No. उक्षेविस/प्रचालन/107/01/2019/3801-3839

दिनांक: 25.04.2019

Subject: Minutes of 37<sup>th</sup> Protection Sub-Committee Meeting.

**Minutes of 37<sup>th</sup> meeting of Protection Sub-Committee (PSC) held on 21.01.2019 at 10:30 hrs. at NRPC Secretariat, New Delhi**

## DR details of 400 kV Gorakhpur PG(end)-Gorakhpur UP ckt-2

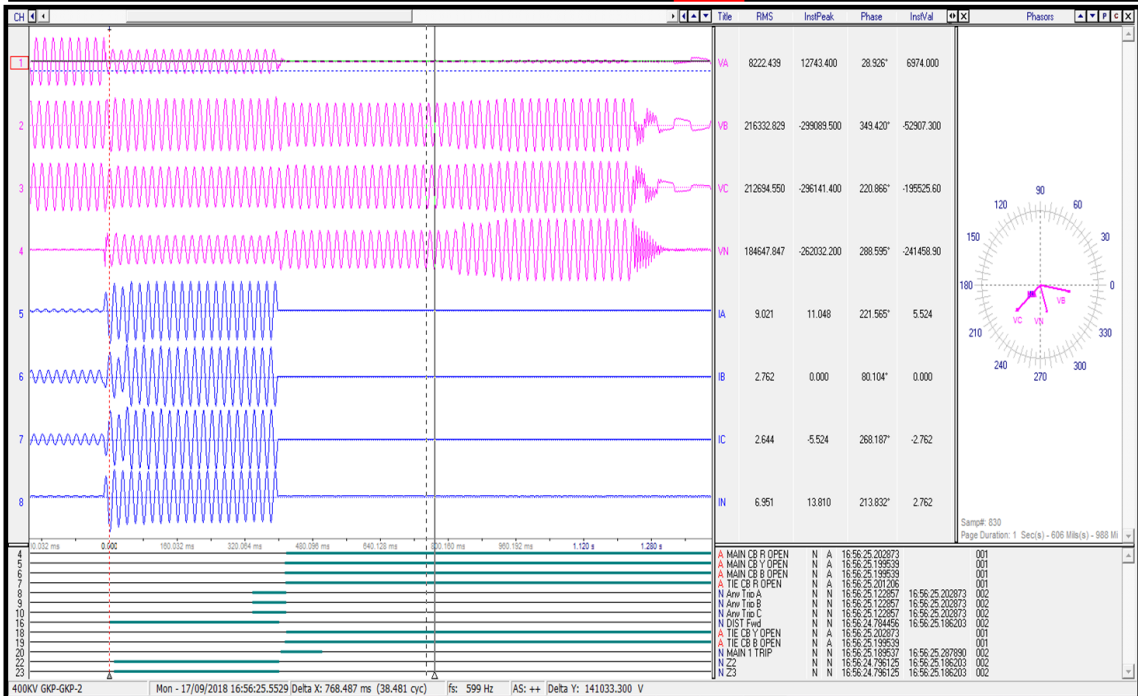
It seems line tripped from PG end in Z-2. Gorakhpur (UP) end connected for another 800ms as voltage persisted for that period.

## DR of 220kV KTPS (end)-Sakatpura ckt-2

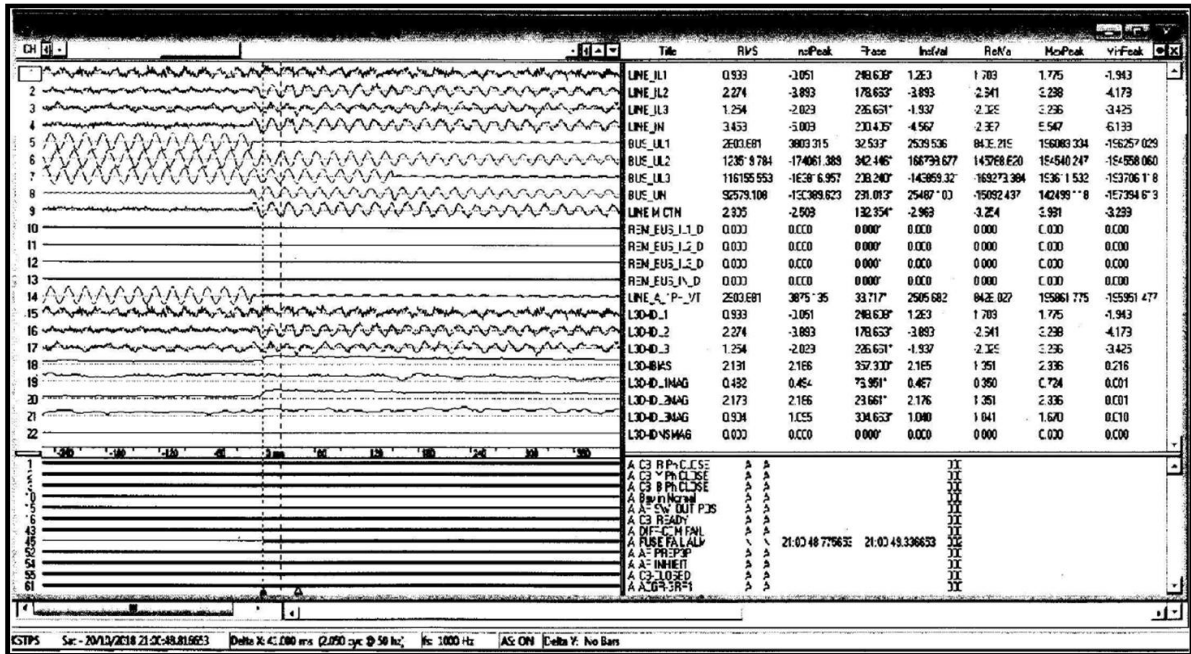
Differential protection didn't operate. Line tripped from Sakatpura end on O/C E/F protection

# DR of 220kV KTPS (end)-Sakatpura ckt-4

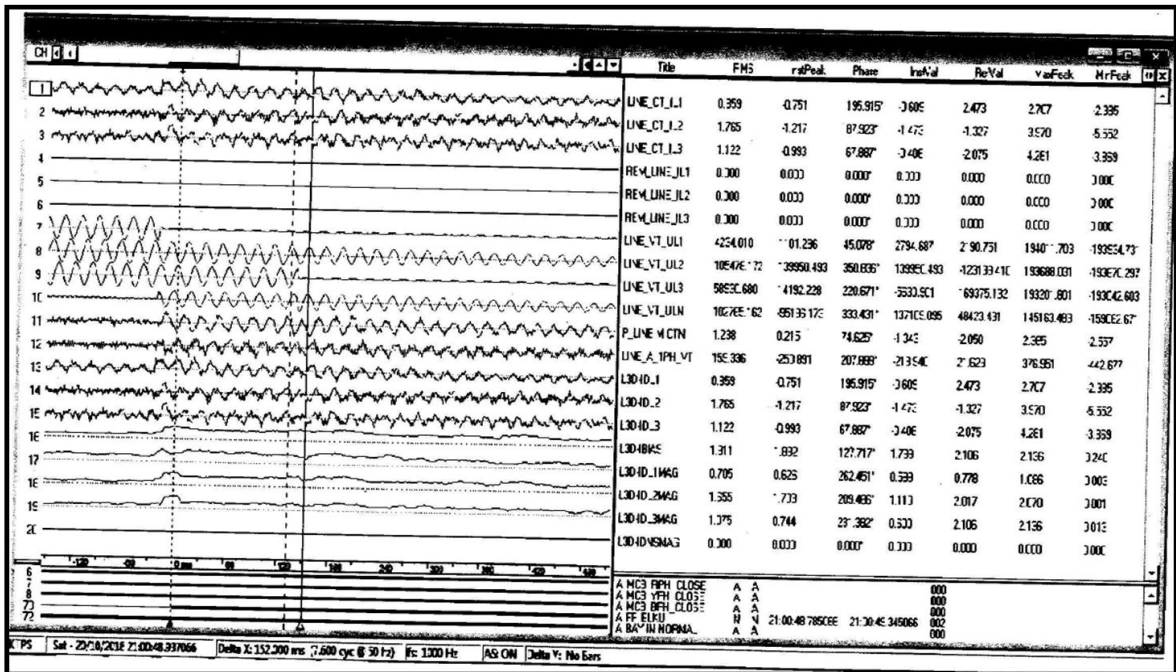
Differential protection didn't operate. Line tripped from Sakatpura end on O/C E/F protection

# DR of 220kV Sakatpura (end)-KTPS 2

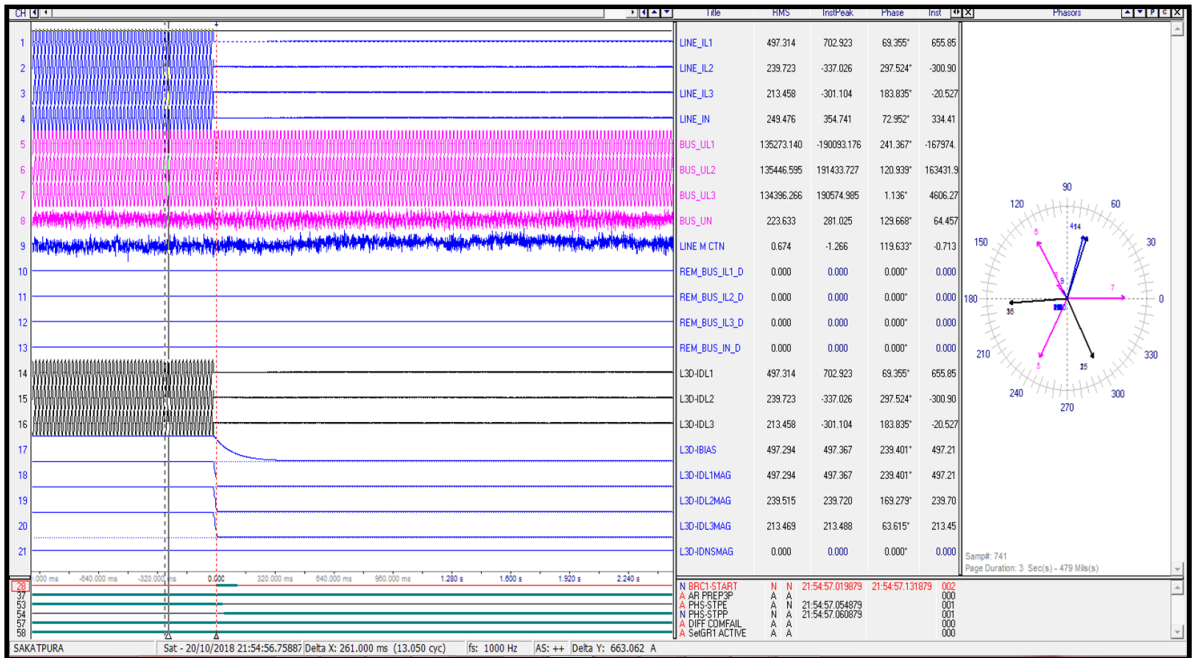
Time Synch error, as DR triggering time is different from actual fault time

# DR of 220kV Sakatpura (end)-KTPS 4

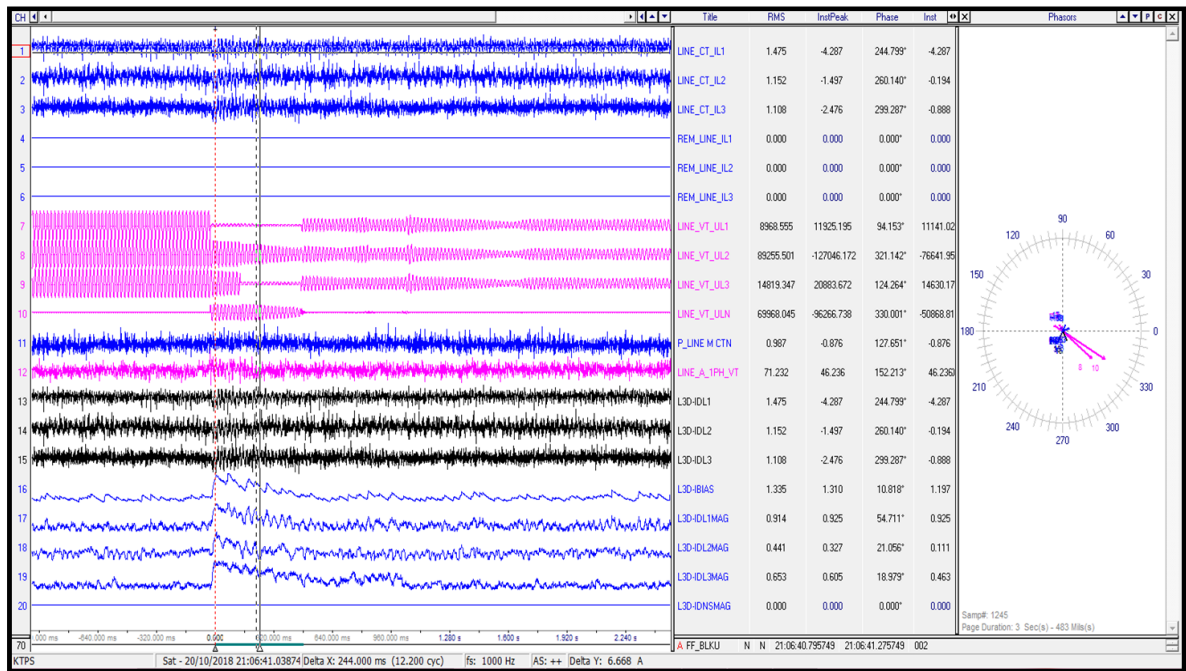
Time Synch error, as DR triggering time is different from actual fault time

## DR of 220 kV Bhiwadi (PG) (end)-Kushkhera

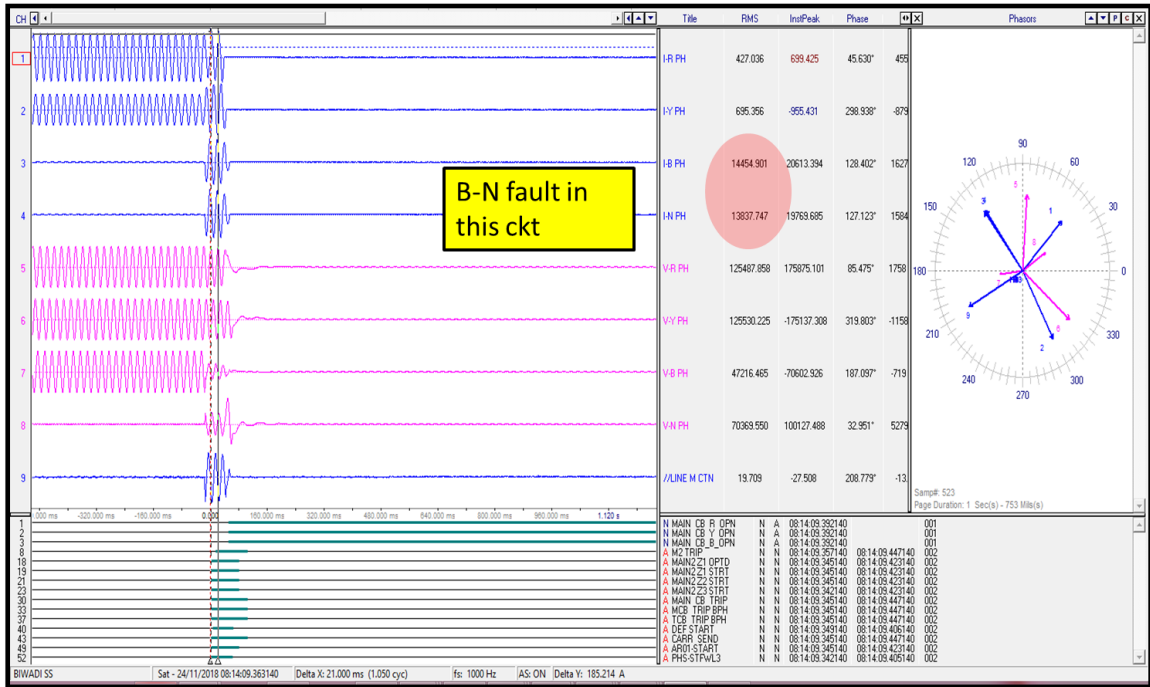
All three phase of the line tripped from both end without any auto reclosure operation on B-N (Blue phase) fault. A/R needs to be checked and put in service at both end.

## DR of 220 kV Bhiwadi (PG) (end)-Bhiwadi (Raj) ckt-2

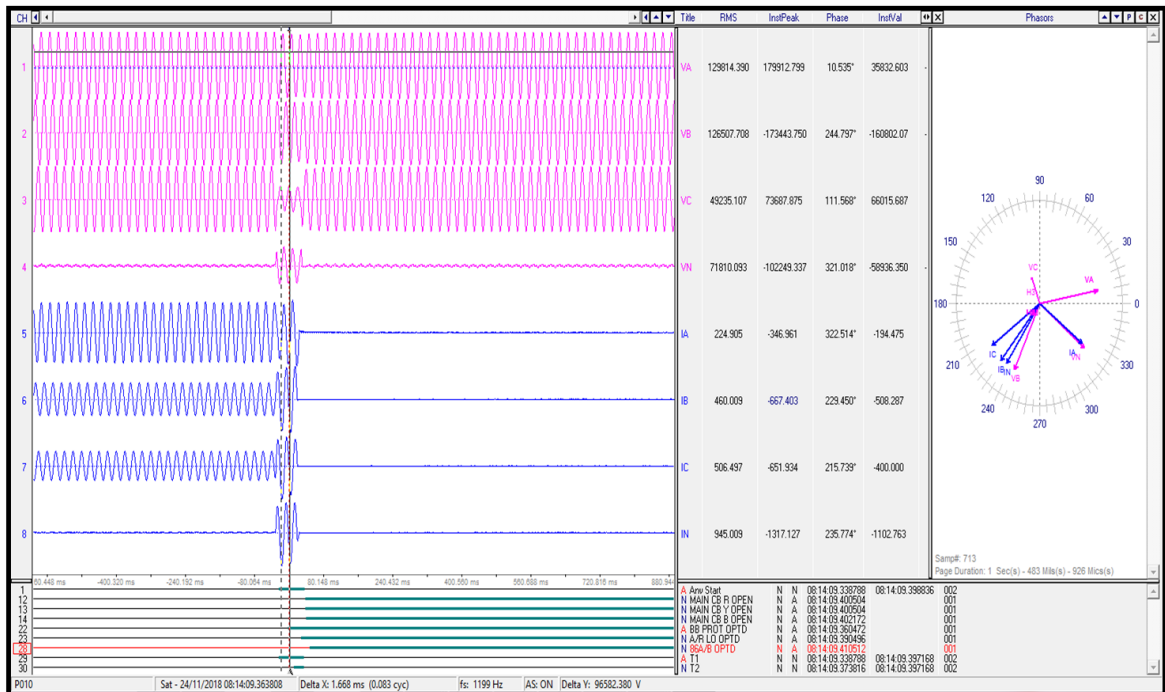
Tripped on master trip relay operation

## DR of 220 kV Bhiwadi (PG) (end)-Mau

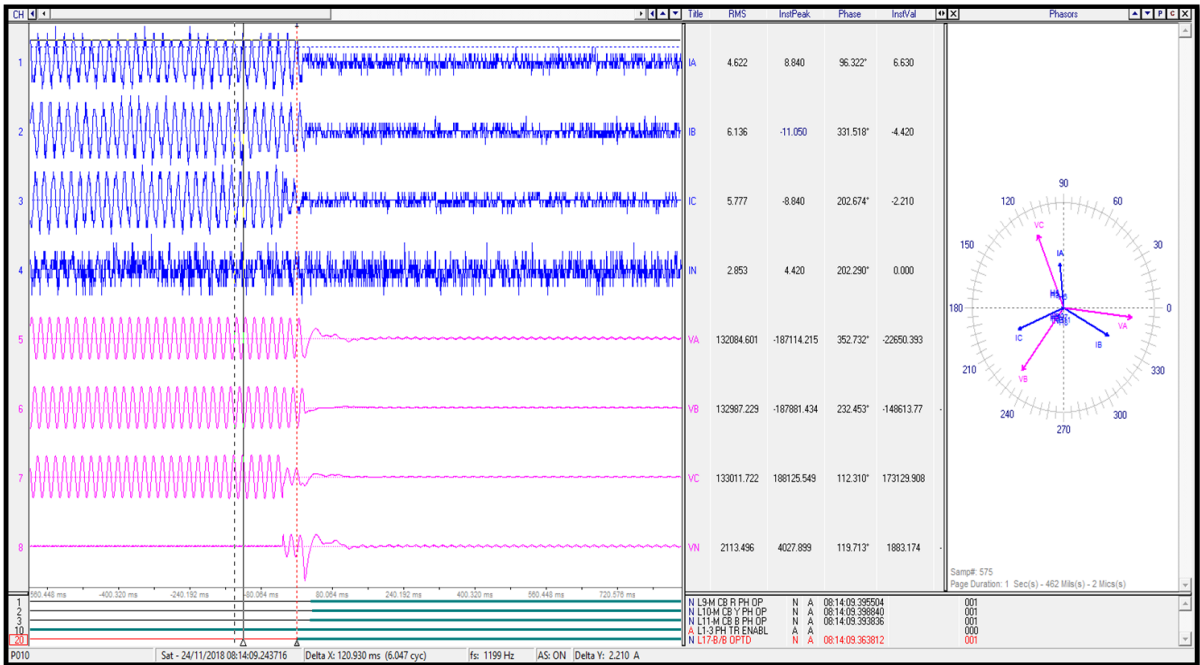
It seems line charged from Bhiwadi (PG) end only. Bus Bar protection operated at Bhiwadi (PG)

## DR of 220 kV Bhiwadi (PG) (end)-Rewari ckt-2

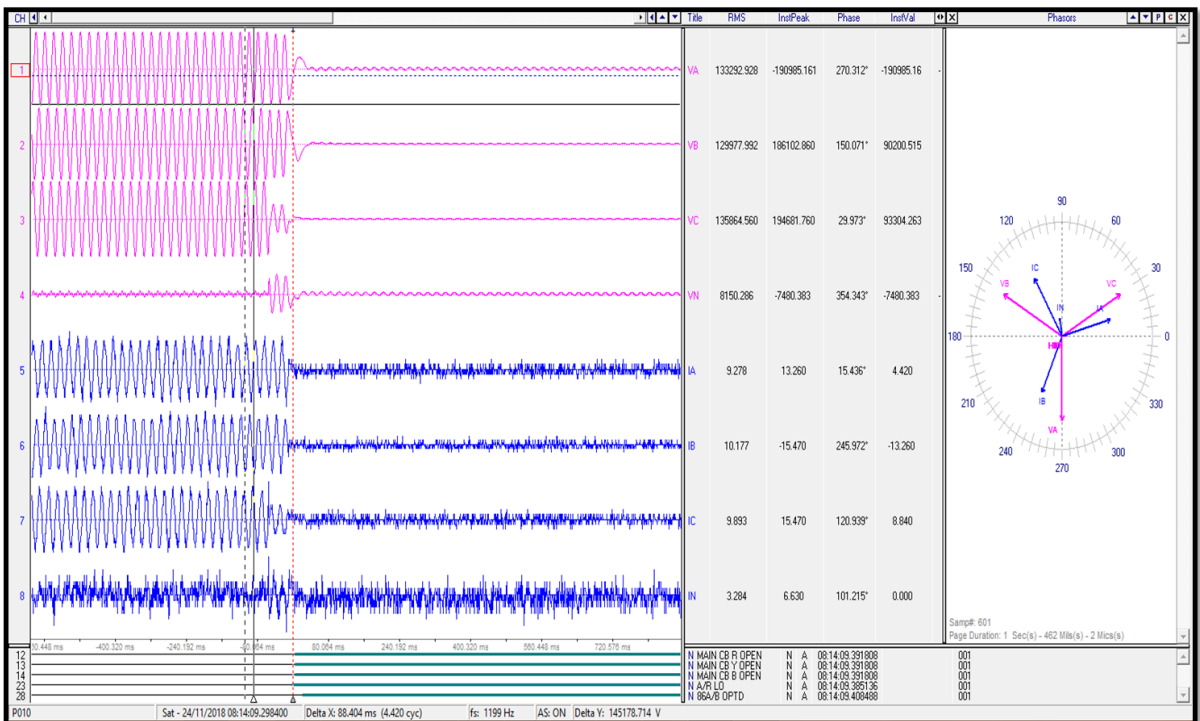
It seems line charged from Bhiwadi (PG) end only. Bus Bar protection operated at Bhiwadi (PG)

## DR of 400 kV Kirori (end)-Kheddar ckt-2

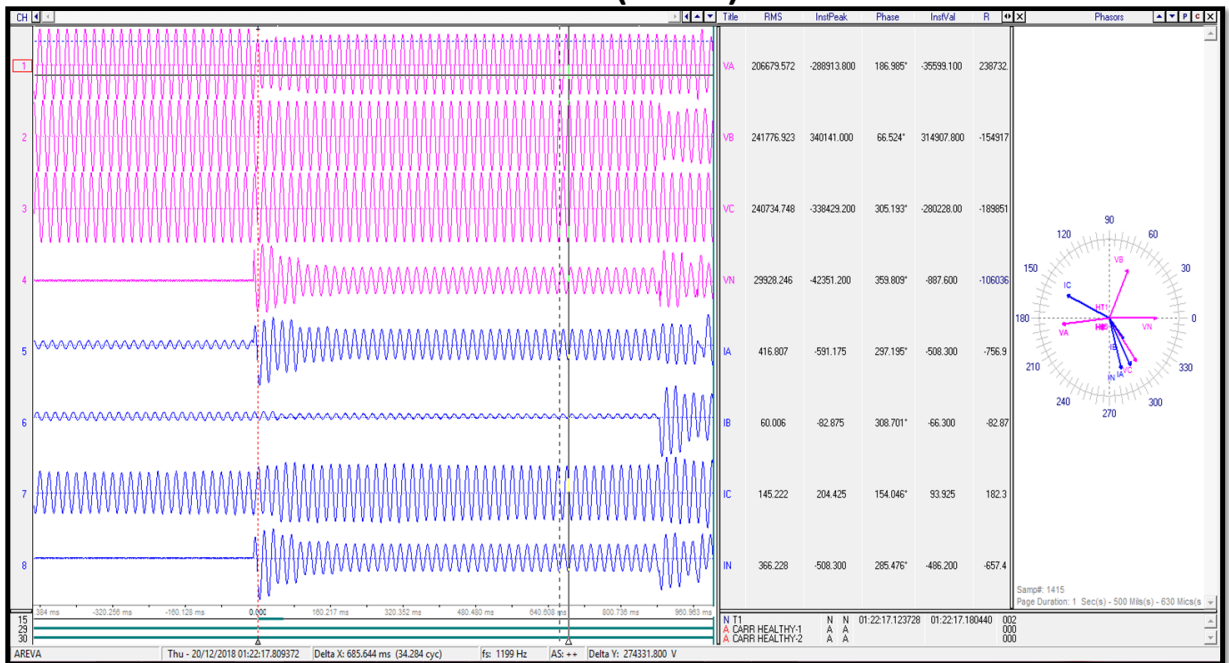
It seems line didn't trip from Kirori end however as per SCADA SoE line tripped within 320ms from Kirori end.

## DR of 400 kV Kirori (end)-Khedar ckt-2

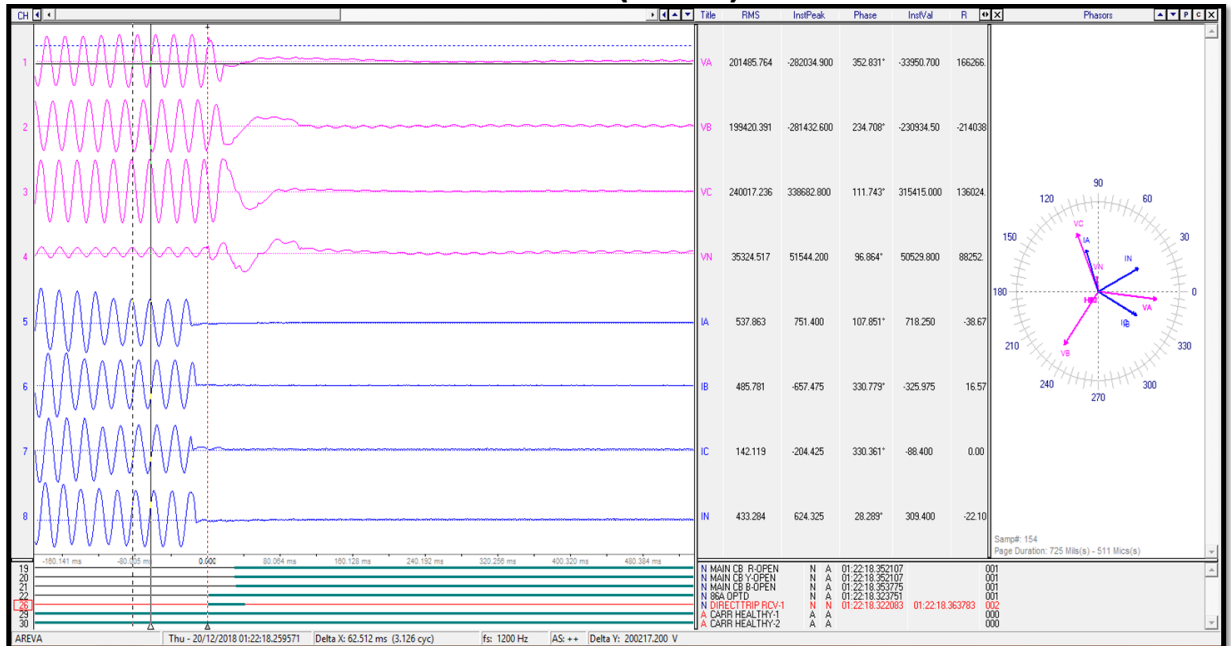
It seems line didn't trip from Kirori end however as per SCADA SoE line tripped within 320ms from Kirori end.
